**DECLARATION OF JEFFREY V.
DAGDIGIAN, PhD**

Technical Response To Shell's Comment Letter

**Former Kast Property Tank Farm
Revised CAO No. RB4-2011-0046
Carousel Housing Tract
Carson, California**

June 30, 2014

Figure 2.30 Typical Values for Capillary Rise in Various Soils

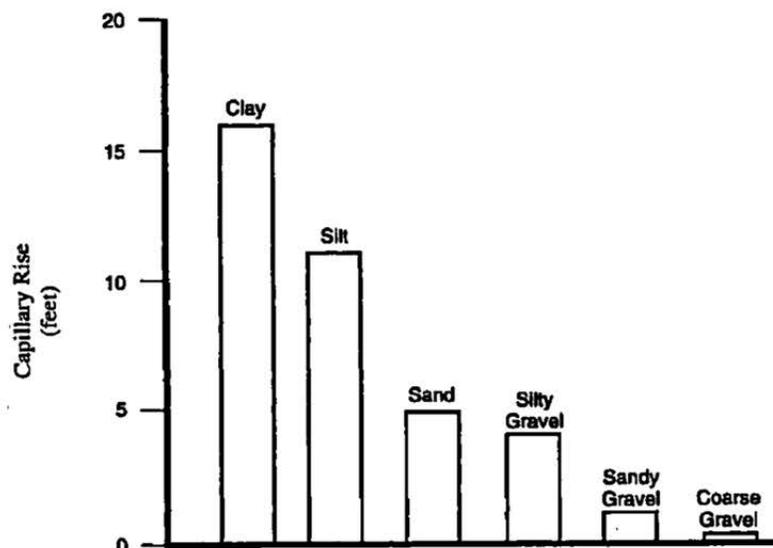
To further clarify, the values of capillary rise cited in the January 2014 Technical Response and stated above are taken from Figure 2.30 of Dragun¹⁰ which is provided below with the accompanying text. The title on the figure is “**Typical Values for Capillary Rise in Various Soils.**” These typical values for capillary rise in various soils apply to the Subject Property

Dragun cites the capillary rise values for different soil types and explains further on page 214 and 215¹¹ (emphasis added) that “The capillary fringe **does not exert a significant effect**, for the most part, on the movement of chemicals in unsaturated soils.” Dragun (p. 214) is now referring to dissolved phased transport of chemical upward through the capillary fringe which has nothing to do with the capillary rise values cited by Waterstone.

When I use the correct capillary rise of water in various soils and Mr. Johnson’s own equations, I find that the capillary rise of Petroleum Hydrocarbons is 5.2 feet in silty soil materials and 7.4 feet in clayey soil materials. To arrive at these results, I used the same formula cited by Mr. Johnson along with his assumptions. Those assumptions included utilization of the average published values for surface tension and density for the petroleum products. I also used, for consistency; Waterstone’s original cited “Typical Values for Capillary Rise in Various Soils” which are valid and representative for the Subject Property. The following calculated heights of capillary rise for petroleum products in the same soil types would be expected:

Figure 4. P-S curves for coarse and fine sand and both LNAPL.

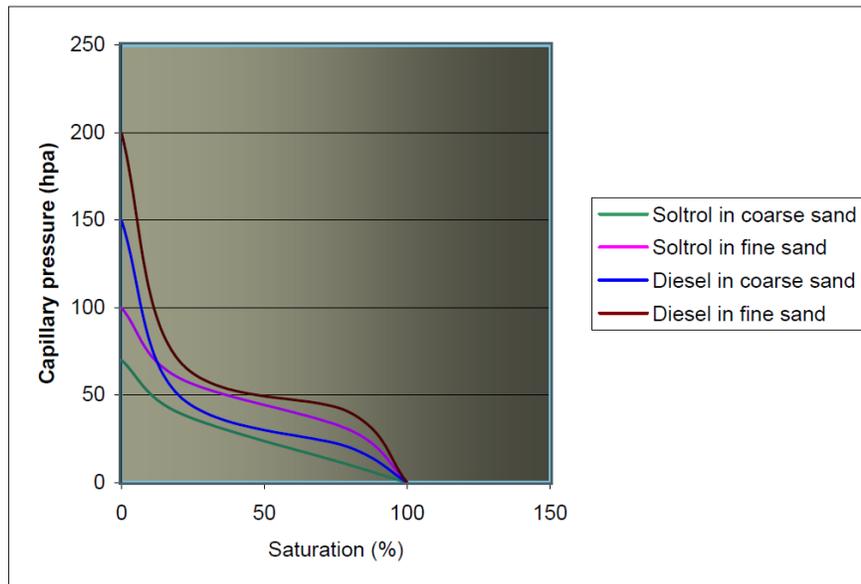
Next the authors reference Figure 4, which is shown below.

Mr. Johnson's statement that the results are not relevant disregards this useful and useable information and is, therefore, another example of a misleading conclusion. The fact that the study investigated the downward movement pattern of various petroleum products is irrelevant. The important part of the study for the issues now before the RWQCB is the use of laboratory data to create pressure saturation curves for various soil types and petroleum products. It is significant and relevant to the Subject Property evaluation that saturation curves for diesel fuel were prepared because diesel-range hydrocarbons are the dominant petroleum hydrocarbon range representing soil contamination on the Subject Property.

FIGURE
1-2

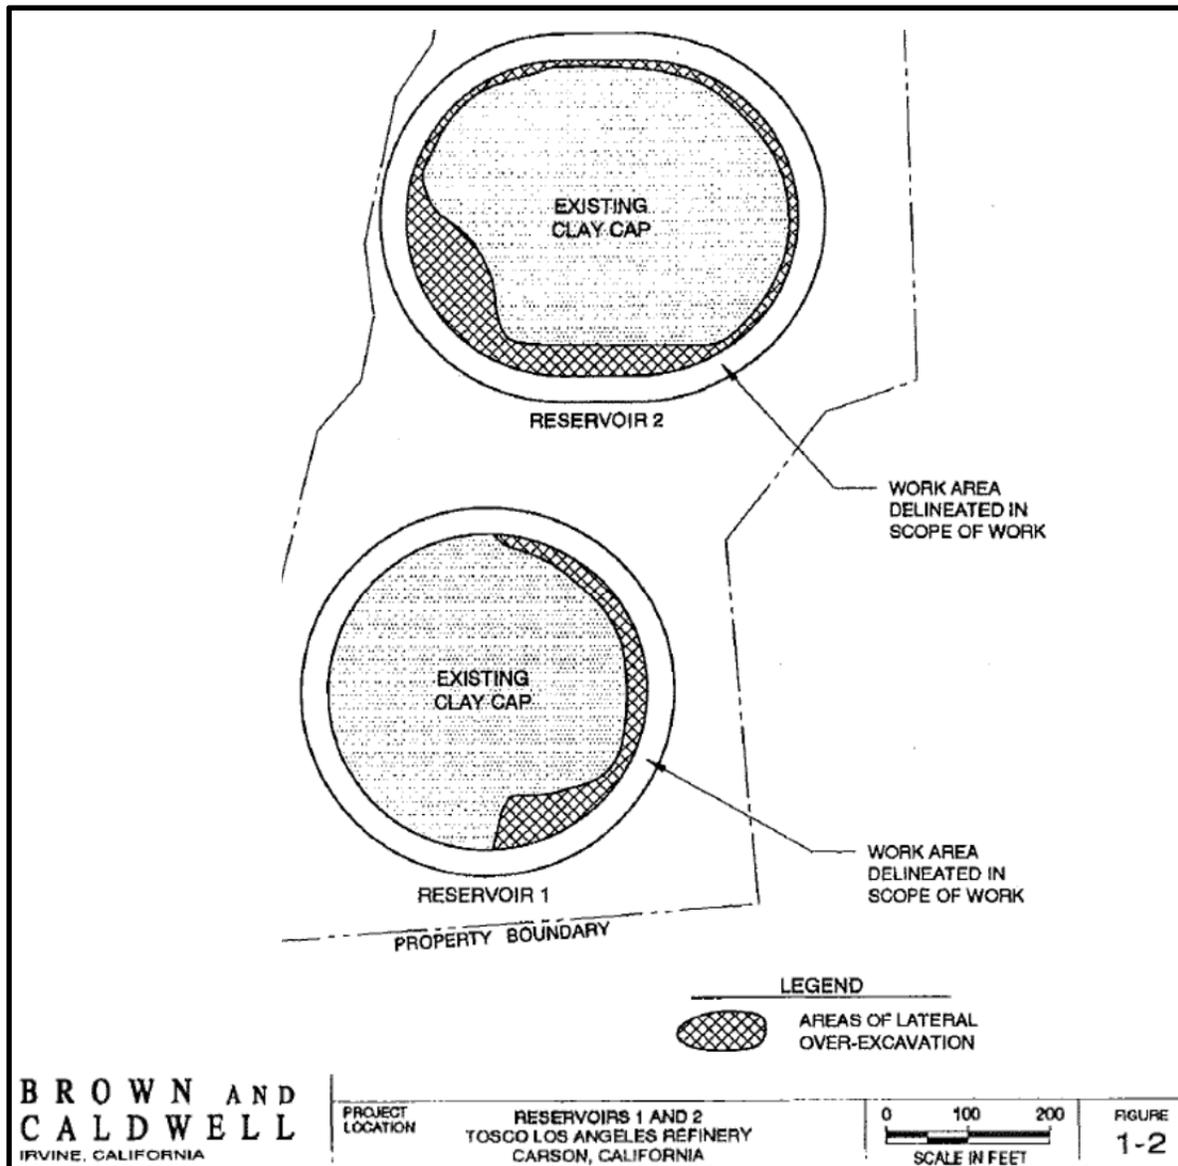
The reality is that separate-phase petroleum and high concentrations of petroleum required the removal of a minimum of 5 lateral feet of the existing clay cap.³³ The removal of the minimum 5 lateral feet of existing clay cap was designated as “planned excavation areas” and generally extended 2.5 to 4 feet below ground surface. In addition to “planned excavation” of 5 lateral feet of the pre-existing low permeability cap, a significant amount of “over-excavation” was required to address “soils exposed during excavation which contained residual liquid hydrocarbons or were wet with hydrocarbons were removed for subsequent off-site treatment...The removed soils were combined with the soils from the planned excavation areas and exported to an off-site thermal treatment facility.”³⁴ As illustrated on the figure below (Figure 1-2 from the 1997 *Low*

Permeability Cap Extension - Addendum 1 of the Backfill and Final Project Completion Report, Reservoirs 1 and 2 the area of “over-excavation” beyond the initial 5 feet of “planned excavation” is extensive and not “immediately outside the area of the initial soil covers” (emphasis added) as claimed by Mr. Johnson but rather what appears to be as much as 15 feet *inside* the original cap perimeter.

3.2.2 Analysis Outside the Footprint of the Former Reservoirs

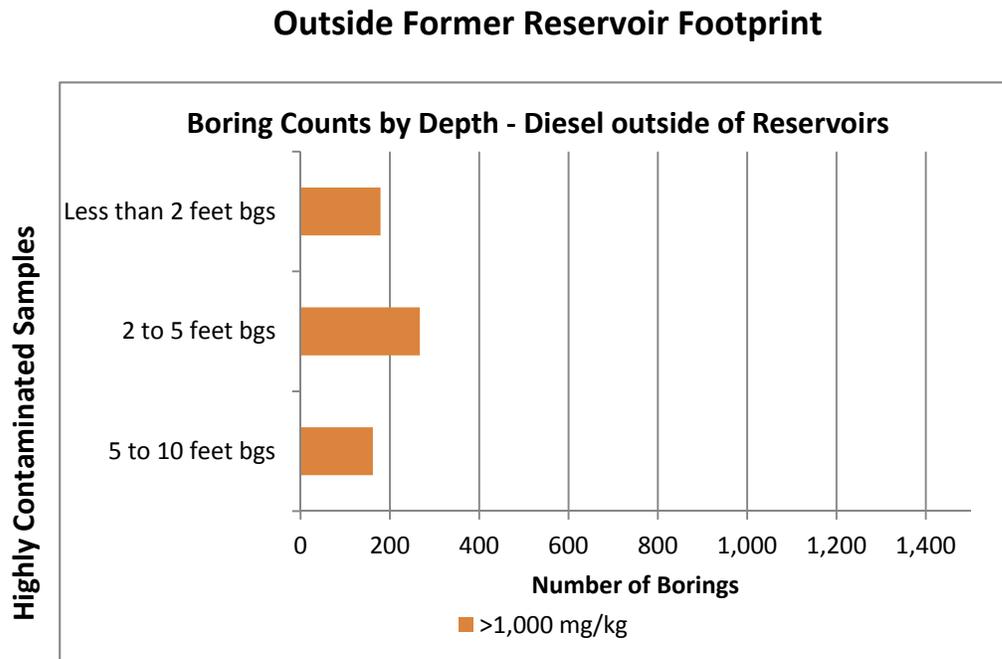
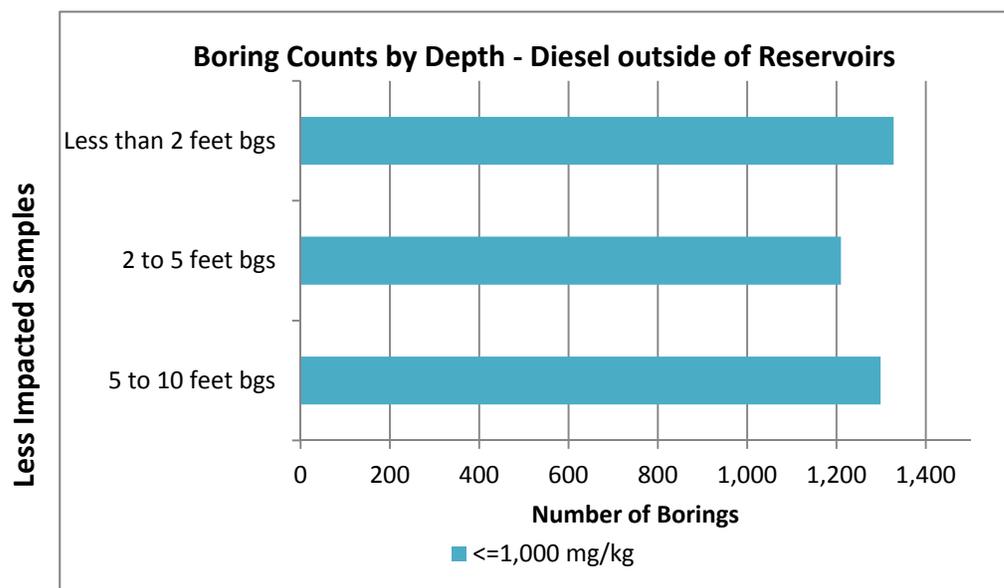
Of the approximately 1,601 locations outside the reservoir footprints, the distribution by depth and concentration is shown below.

Outside the footprint of the former reservoirs, the distribution of TPHd with depth is markedly different than that observed within the reservoir footprint. My analysis shows that the amount of contamination was generally lower outside compared to within the reservoirs and fairly even across all three depth intervals. However, for the two to five-foot depth range, the number of borings having TPHd greater than 1,000 mg/kg and TPHmo greater than 10,000 mg/kg is slightly more than the other depths. This is likely attributable to the samples located in the former sump area east of Reservoir No. 5, where soil impact was concentrated at that intermediate depth interval.

This shows that the mechanism for distribution of contaminants outside the reservoir footprint was different than that within the reservoir footprint. My January 2014 Technical Response details the source of contaminants within various areas outside of the former reservoir footprint.

**Figure 1
Reservoir 1 - East Berm Profile
Pre and Post Cap Extension**

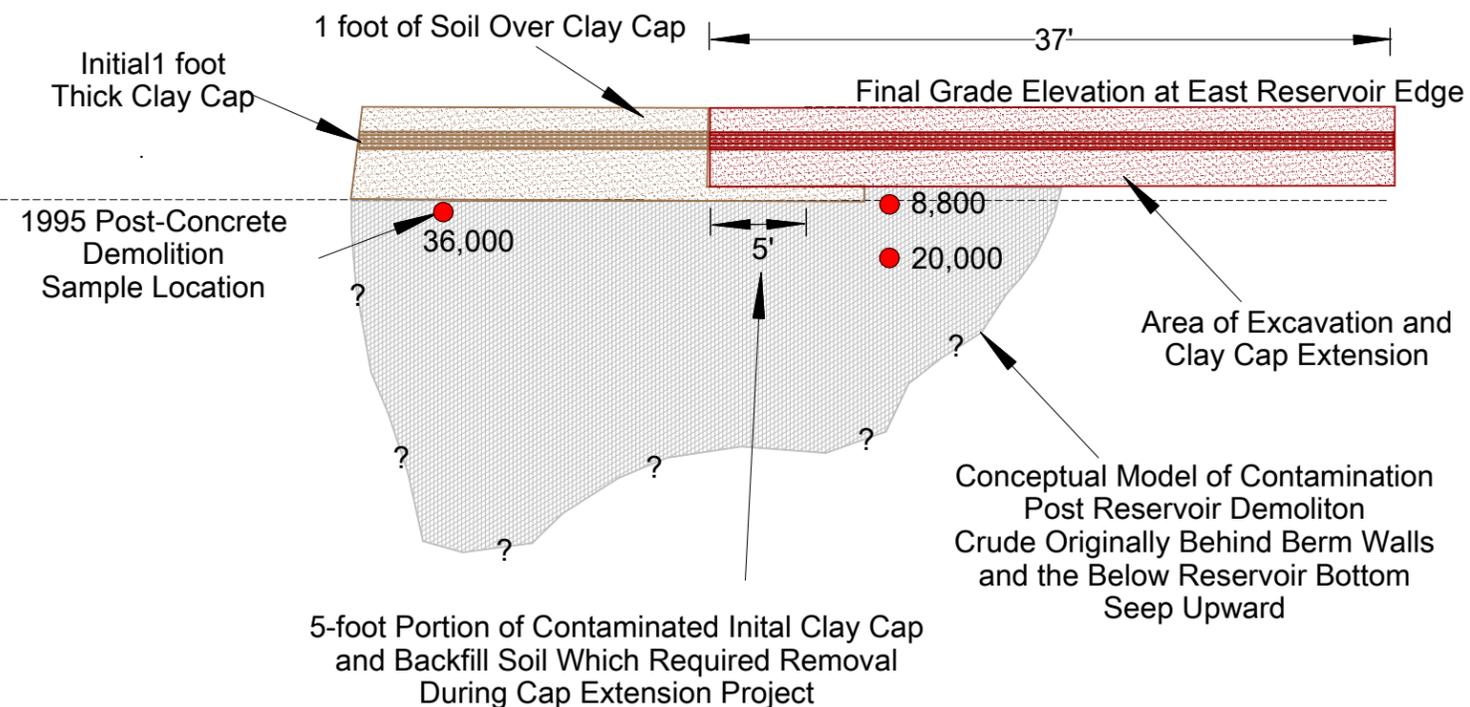
**Cross Section
Reservoir 1 East Berm Profile
Prior to Cap Extension**

**Cross Section
Reservoir 1 East Berm Profile
After Cap Extension**
